Access Compliance Report

Public Rights-of-Way

(Curb Ramps)

Intersection ID: 3490	Main Street: PRESERVATION_POINTE_DR	Cross Street: TRANQUILLITY_DR	Location: NW
ADA ID: 7F740559B434	Ramp Type: Perp	Initial Pass/Fail: Fail	Overall Compliance: No
Severity Score: 22.5			
Codes/Mitigation Info/Possible Solution		Field Measurements/Component Compliance

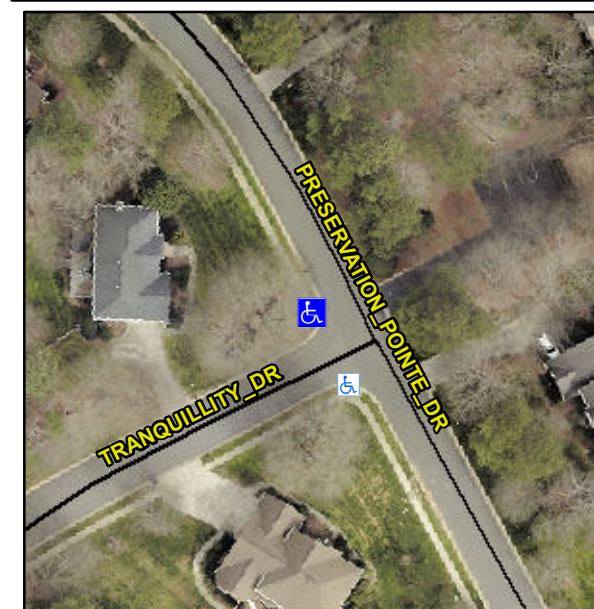
Not Found, R304.5.1, R304.2.2, R304.5.3

Compliance	Description	Data	Compliance	Description	Data
N/A	Ramp Length (in)	48.0	No	Ramp Slope (%)	10.0
No	Ramp Width (in)	44.0	No	Ramp XSlope (%)	4.3
N/A	Flare Type LT	N/A	N/A	Flare Type RT	N/A
N/A	Flare Slope LT (%)	N/A	N/A	Flare Slope RT (%)	N/A
N/A	Flare Traversable LT?	N/A	N/A	Flare Traversable RT?	N/A
N/A	Landing Length (in)	N/A	N/A	DWS Provided?	N/A
N/A	Landing Width (in)	N/A	N/A	DWS Contrast?	N/A
N/A	Landing Slope (%)	N/A	N/A	DWS Length (in)	N/A
N/A	Landing X Slope (%)	N/A	N/A	DWS Full Width?	N/A
N/A	Landing Curb? (Y/N)	N/A	N/A	DWS Offset (in)	N/A
N/A	Shared Landing?	N/A			
N/A	Gutter Ponding?	N/A	N/A	Gutter Slope (%)	N/A
N/A	Gutter Lip Ht (in)	N/A	N/A	Gutter X Slope (%)	N/A
N/A	Painted X Walk1?	No	N/A	Painted X Walk2?	N/A
	X Walk 1 Direction	To SE		X Walk 2 Direction	N/A
N/A	X Walk 1 Width (in)	N/A	N/A	X Walk 2 Width (in)	N/A
	X Walk 1 Slope (%)	0.1		X Walk 2 Slope (%)	N/A
	X Walk 1 X Slope (%)	3.0		X Walk 2 X Slope (%)	N/A

Remove & Replace Entire Ramp.
